Groundwater Application Review Summary Form

Application # G- 18882

PUBLIC INTEREST REVIEW FOR GROUNDWATER APPLICATIONS

TO: Water Rights Section Date 12/17/2019
 FROM: Groundwater Section Phillip I. Marcy
 Reviewer's Name
 SUBJECT: Application G- 18882 Supersedes review of _____
 Date of Review(s)

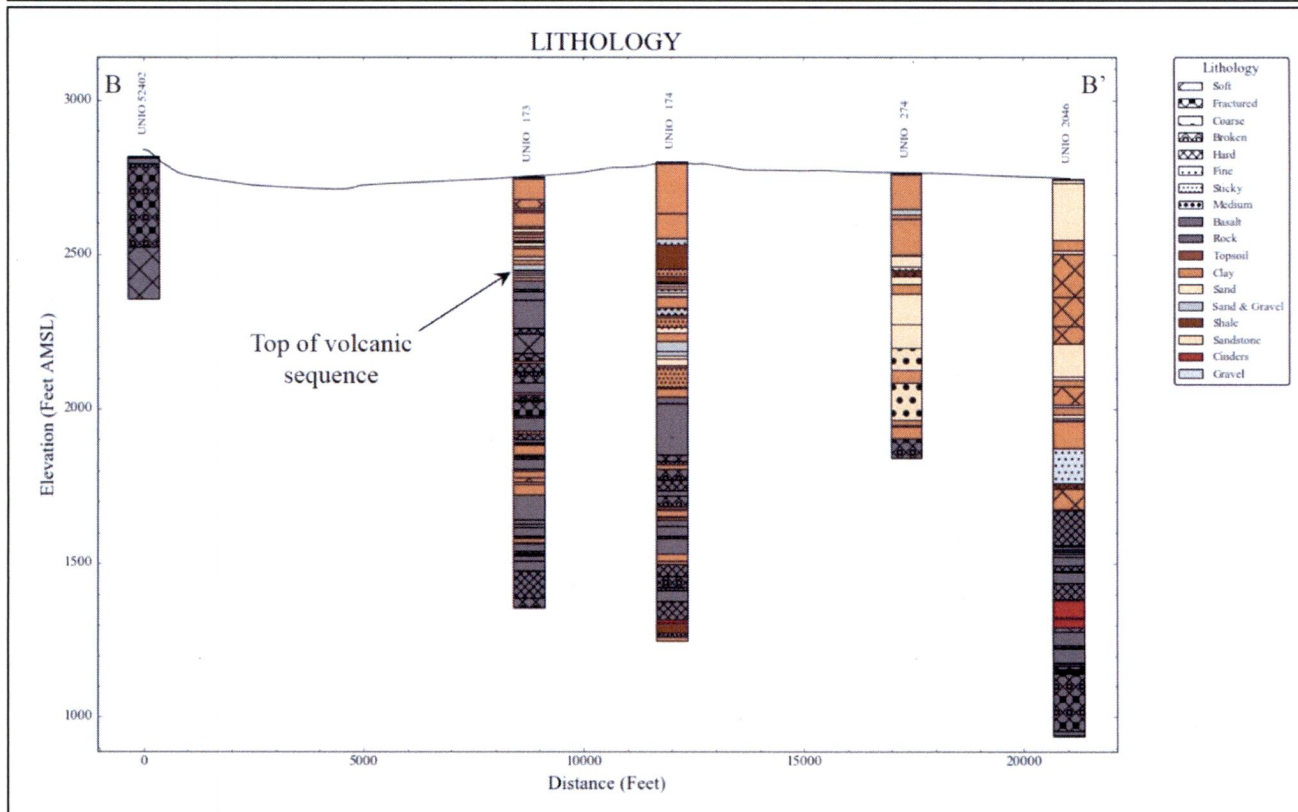
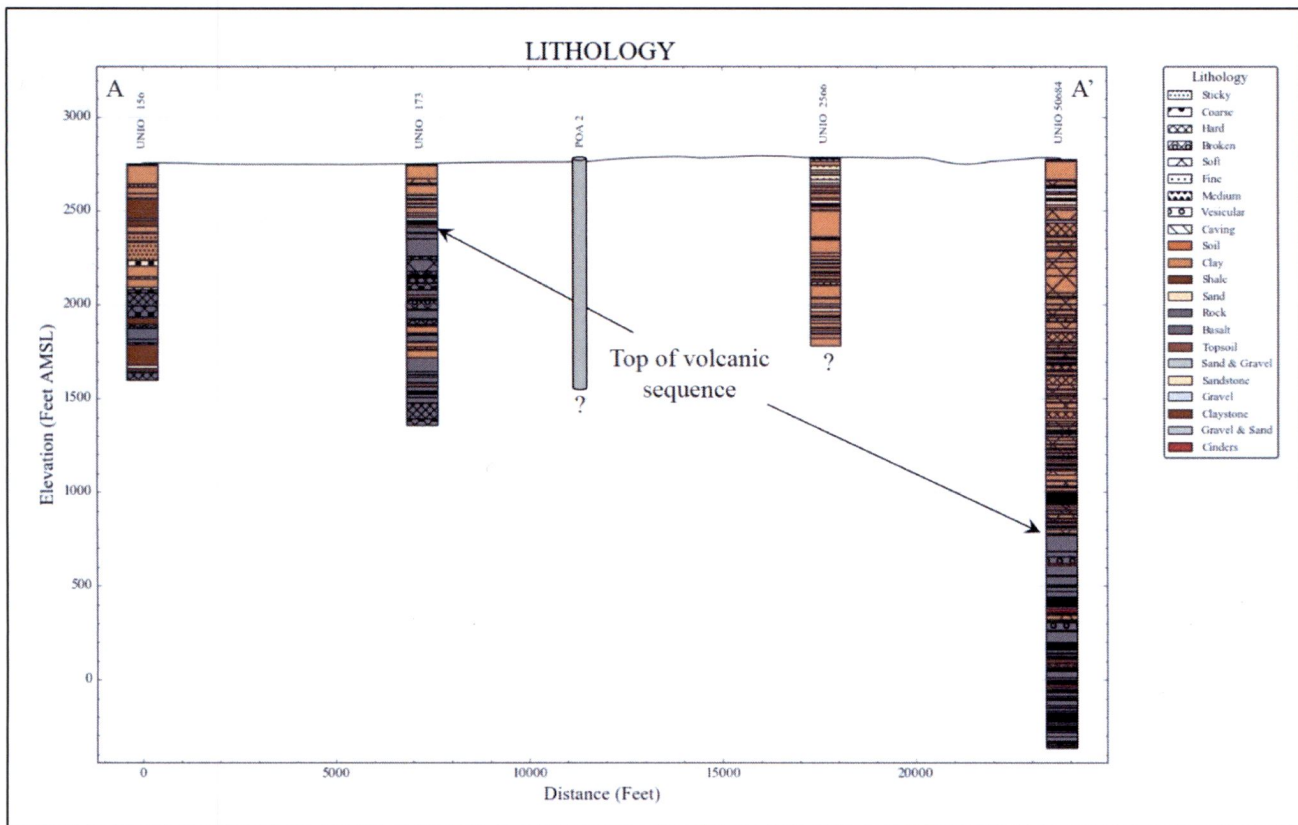
Cross sections constructed from plotting reported lithology in well log reports suggest that depth to volcanic rock at the proposed POA location(s) may vary considerably, depending on the location of buried structures beneath the valley-fill sequence (top: A-A' cross-section; see attached map). Changes in elevation of the top of the volcanic sequence are not as dramatic in the E-W direction as from N-S in this area (bottom: B-B'). Unfortunately, at the present time, there are insufficient data to more accurately pinpoint subsurface faults.

Water-Level Trends in Nearby Wells

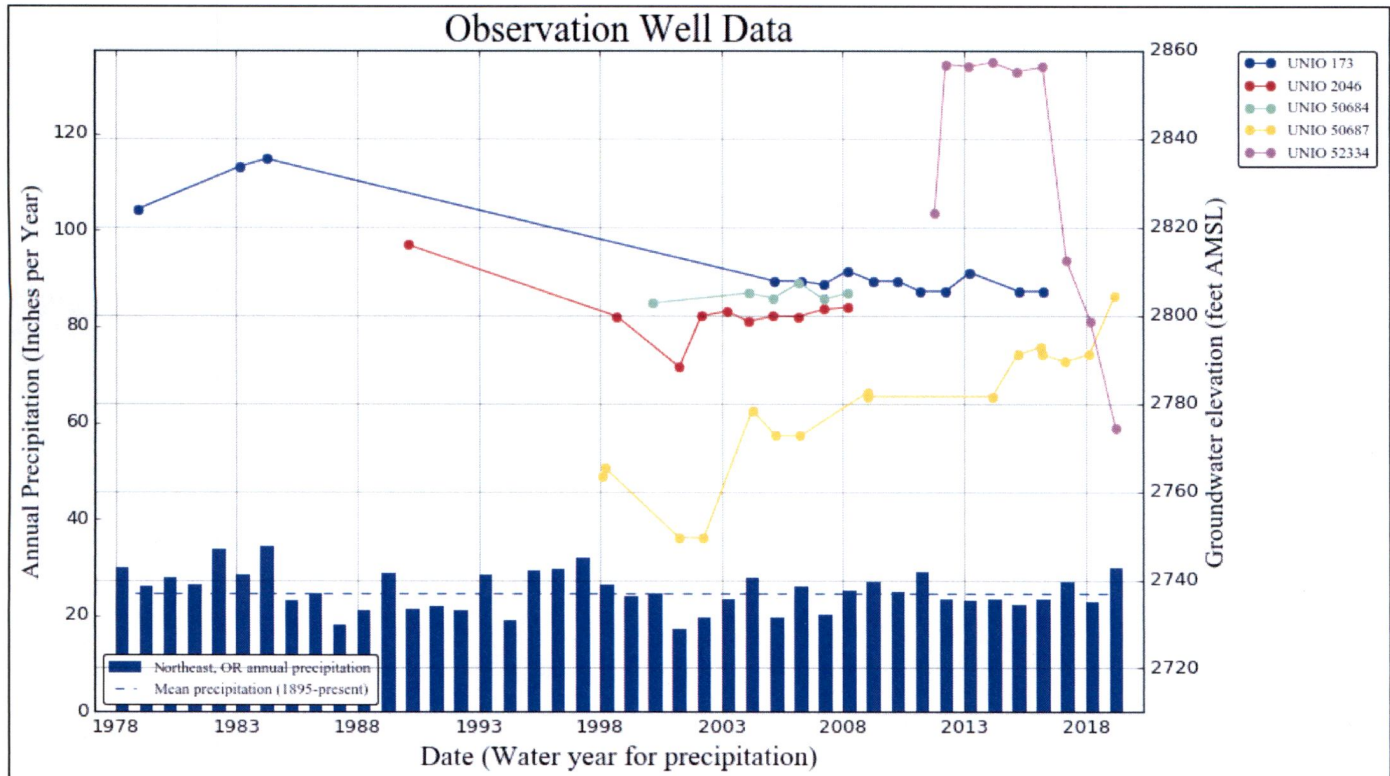
Water level data indicate that wells producing from volcanic rock at very different depths to the north and south (UNIO 173 and UNIO 50684) of the proposed POA locations have very similar head elevations. This suggests that either the hydraulic system is connected across a buried fault responsible for the offset observed here, or that possibly they are completed in the same fault block dipping generally toward the south.
